# SERVICE BULLETIN

M-1180A

December 13, 2005

## SAFETY RECALL-2004 DYNA MODELS THROTTLE CABLE ROUTING

Figure 1. Throttle Cable Routing

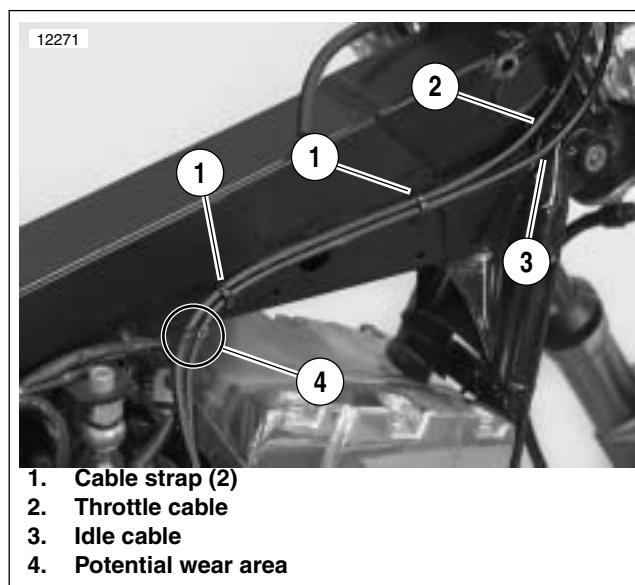
1. Remove fuel tank according to instructions in the 2004 Dyna Models Service Manual.
2. See Figure 1. Remove and discard cable straps (1). Inspect throttle cable (2) and idle cable (3) for wear, particularly the potential wear area (4).
3. Inspect fuel tank for possible wear due to throttle/idle cable contact with tank.

Figure 2. Cable Strap Installation

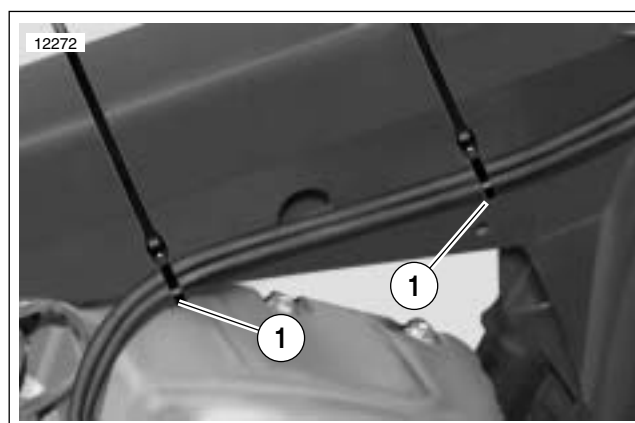
1. See Figure 2. Install **new** cable straps (1) so after installation, ends of cable straps are pointing towards top of vehicle.
2. Install fuel tank according to instructions in the 2004 Dyna Models Service Manual.
3. Complete attached order form for kit 94417.

1. If throttle and/or idle cables are worn, replace cables according to instructions in the 2004 Dyna Models Service Manual.
2. See Figure 2. Install **new** cable straps (1) so after installation, ends of cable straps are facing top of vehicle.

Figure 3. Fuel Tank Inspection Area

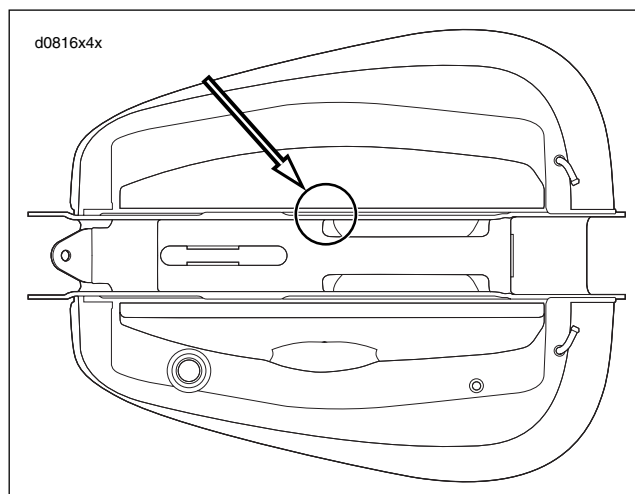
1. See Figure 3. Determine extent of wear on fuel tank:
  - a. If throttle cables have worn or removed paint but have not damaged the metal structure of fuel tank, repair wear using Harley-Davidson Touch-up paint of the correct color.
  - b. If wear has damaged the metal structure of fuel tank, order a new fuel tank according to instructions specified under Credit Procedure.
2. Replace cables according to instructions in the 2004 Dyna Models Service Manual.
3. See Figure 2. Install **new** cable straps (1) so after installation, ends of cable straps are facing top of vehicle.
4. Install fuel tank according to instructions in the 2004 Dyna Models Service Manual.
